Re: Dockets 50-275-OL
50-323-OL

Diablo Canyon Nuclear Power Plant
Physical Model of Thermal Discharge
Telcon with NRC, October 28, 1975

October 30, 1975

Figure III-17. AREA IN ACRES INFLUENCED BY ISOTHERM

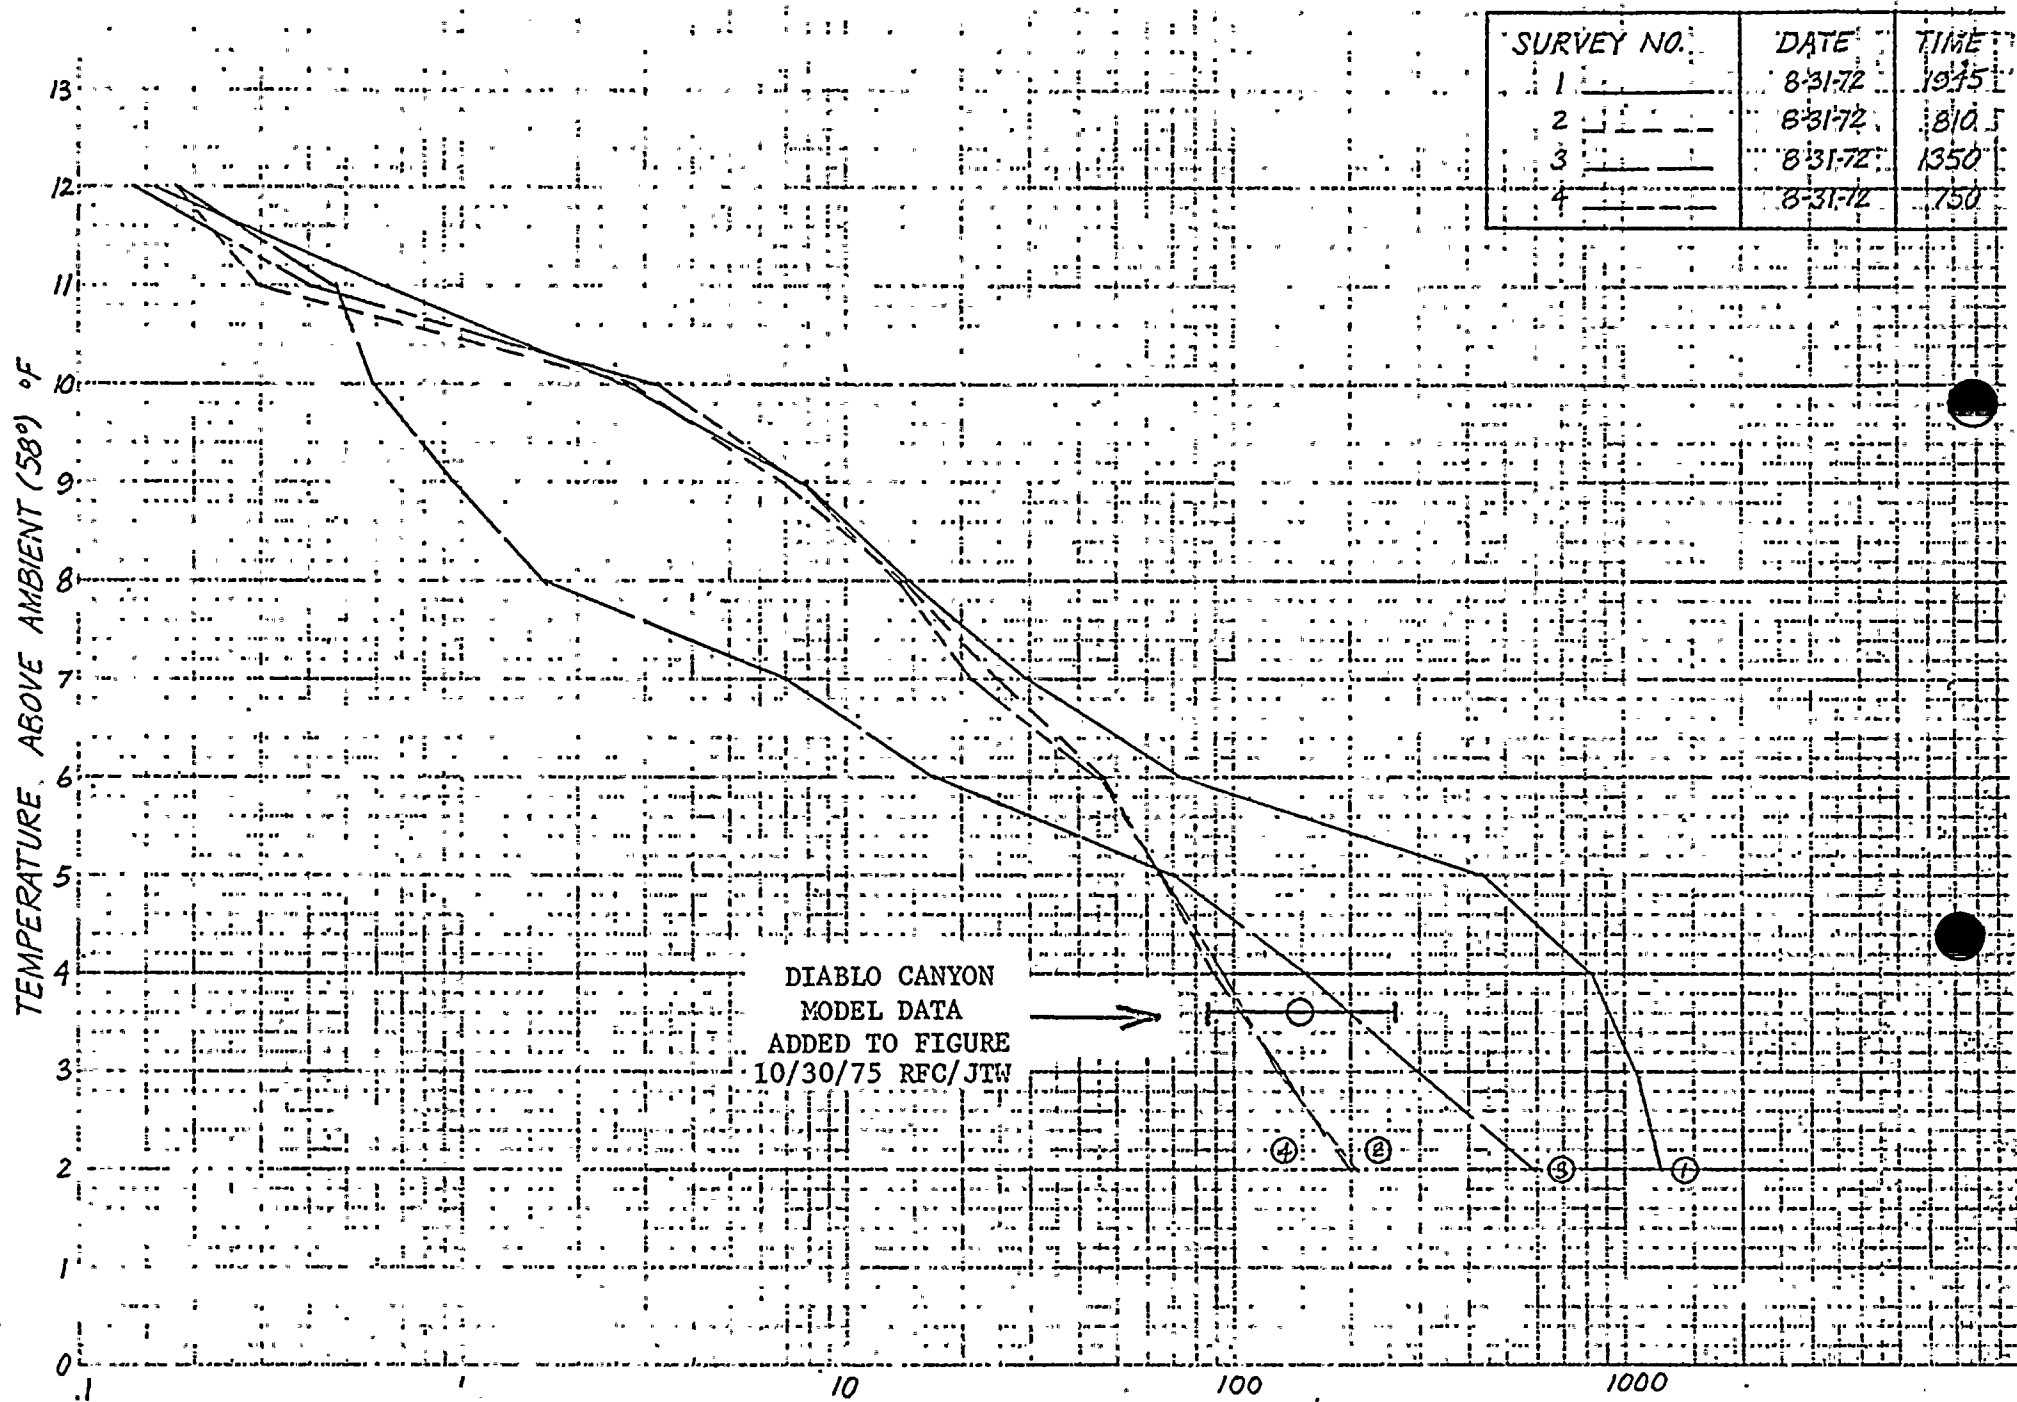
- c. Field studies done at Morro Bay Power Plant under a 1050 MW(e) load and a 19°F condenser temperature rise correlate with the model isotherm predictions. One result of these field studies, which were reported in An Evaluation of the Effect of Warm Water Discharges on the Beneficial Uses of Receiving Water, Morro Bay Power Plant, PGandE, 1973, was the enclosed figure showing the isotherm intensity versus areas enclosed by the isotherms. The range of several model predictions for a 2°C isotherm increment is shown there to fall within the range of Morro Bay field data. Although the Morro Bay discharge structure and flow velocity distribution near the structure are different than those of Diablo Canyon Power Plant, surface water temperature distributions well away from the structures should theoretically be similar so long as the waste heat load and condenser temperature rise are comparable. For that reason, the model agreement with Morro Bay field data at the 2°C isotherm locations is considered significant.
